# STATE OF RHODE ISLAND AND PROVIDENCE PLANTATION DEPARTMENT OF TRANSPORTATION RHODE ISLAND CONTRACT NO.2013-CB-063

### Morgan Ave. Bridge No. 109901

### **NOTICE TO PROSPECTIVE BIDDERS**

ADDENDUM NO. 1 Prospective bidders and all concerned are hereby notified of the following changes in the Plans, Specifications, Proposal and Distribution of Quantities for this contract. These changes shall be incorporated in the Plans, Specifications, Proposal and Distribution of Quantities, and shall become an integral part of the Contract Documents.

1. Plan Sheet 26

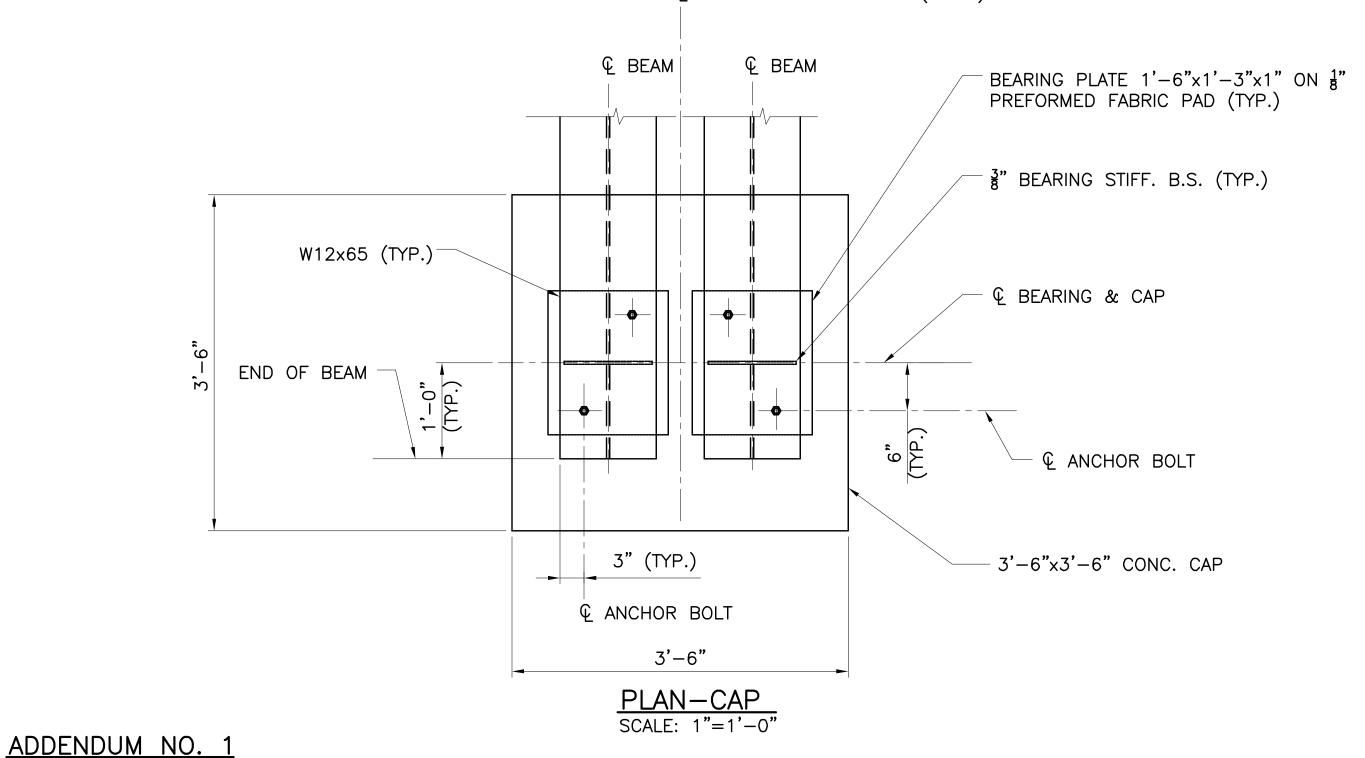
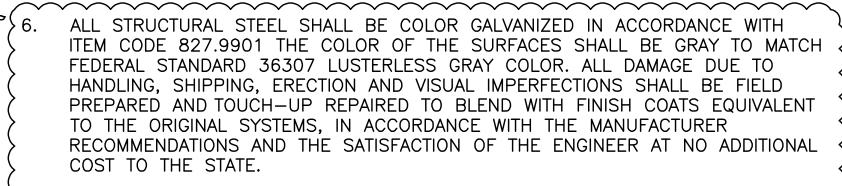
Delete plan sheet 26 in its entirety and replace it with plan sheet 26(R-1) attached to this Addendum No. 1. Note 6 has been revised. Note numbering corrected.
